**REQUEST FOR APPROVAL OF
ALTERNATIVE WASTE MANAGEMENT PRACTICES
(Conventional Operations Only)**

PROJECT IDENTIFICATION					
Well Operator MINARD RUN OIL COMPANY	DEP ID/OGO No. 69329	U.S. Well No. (API No.) 053-31226			
Address 609 SOUTH AVENUE		Well Farm Name Warrant 5110			
City BRADFORD	State PA	Zip Code 16701	Well No. 2608	Serial No.	
Telephone No. 814-362-3531	Fax No. 814-368-4834	County FOREST	Municipality JENKS TOWNSHIP		
Note: All submittals must include the following information: 1) United States Geological Survey (USGS) 7.5-minute quadrangle map showing the location of the proposed alternative waste management practices 2) Full size set of plan design drawings showing proposed facility dimensions and location relative to existing facilities 3) A brief detailed project narrative describing the proposed project					
INTENDED ALTERNATIVE PRACTICE			Check the appropriate box and complete the applicable section of the form.		
☐ For temporary containment of pollutorial substances and wastes generated during drilling, altering, or completing a well; complete section A. Pits and Tanks for Temporary Containment. See 25 Pa. Code § 78.56 for regulations.

WELL LOCATION PLAT

DRAWI

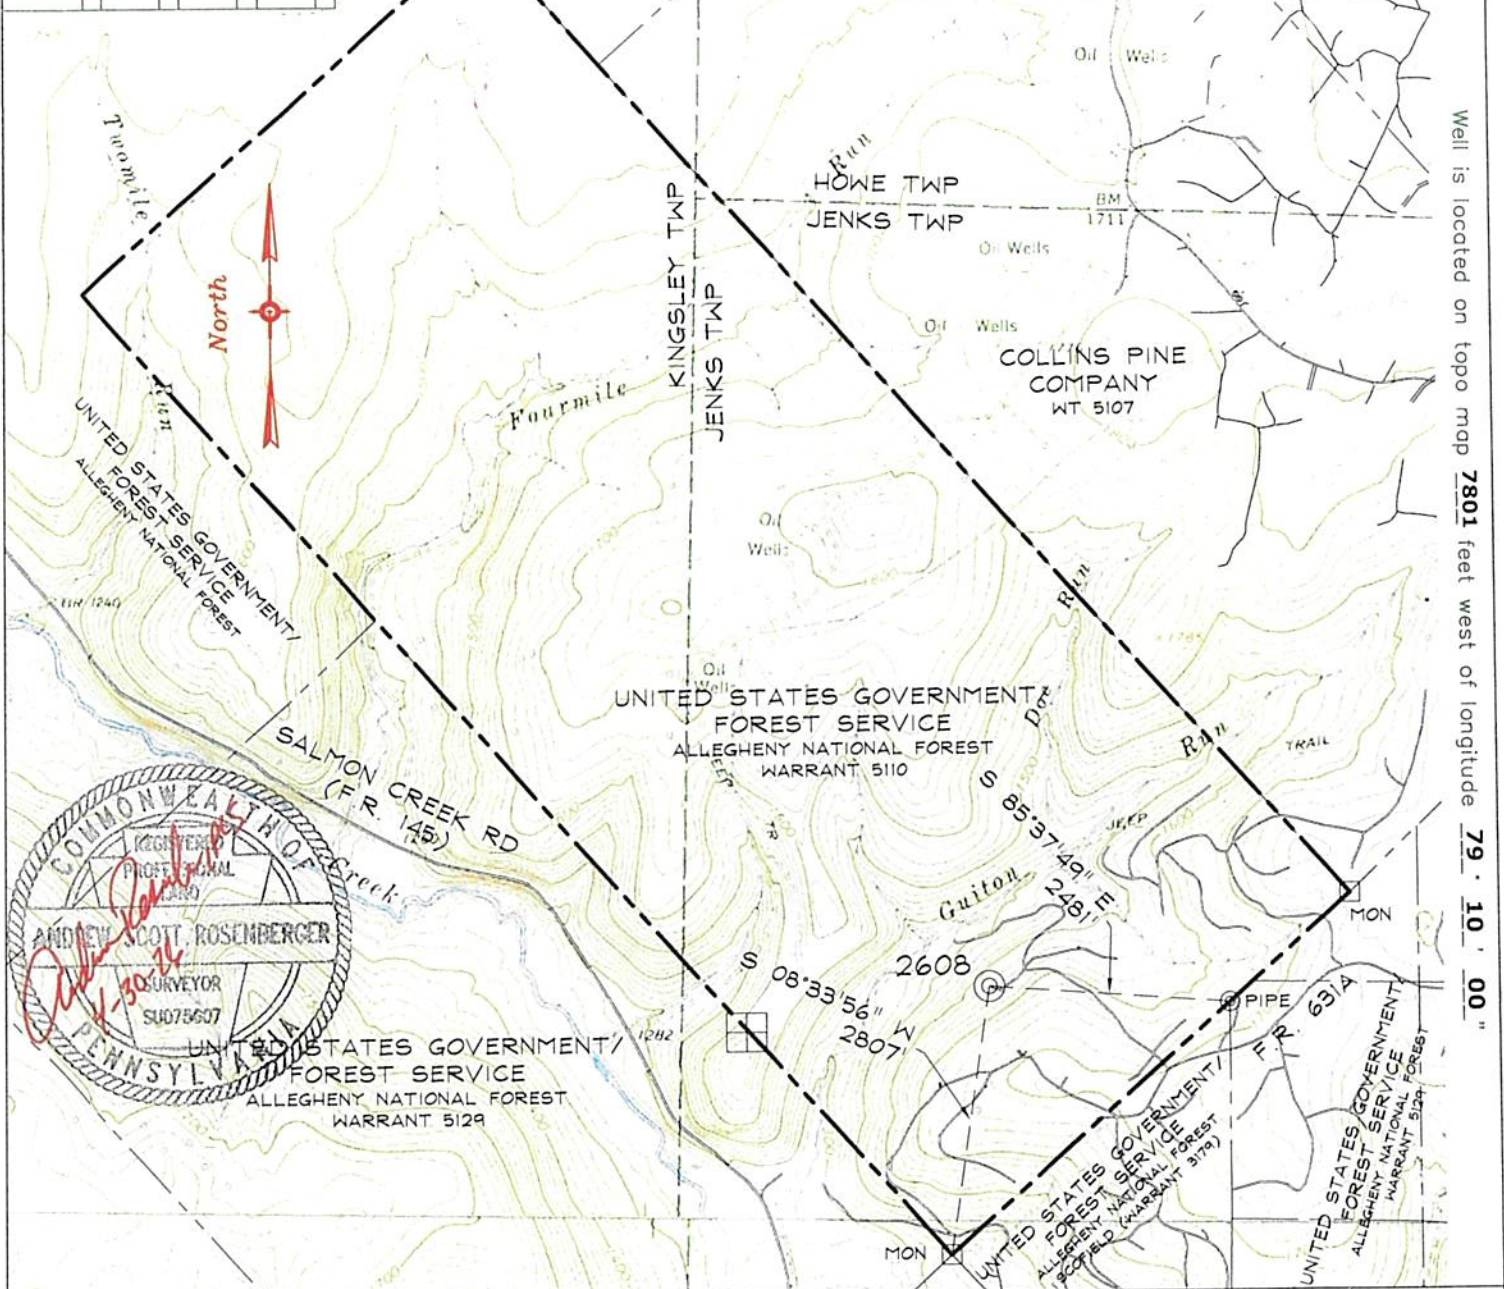
A site evaluation determined that this site is unsuited for the proposed Alternate Waste Management Practices. The operator may resubmit the Request for Approval of Alternate Waste Management Practices if they can demonstrate that shallow groundwater will not compromise the drill pit on this well site.
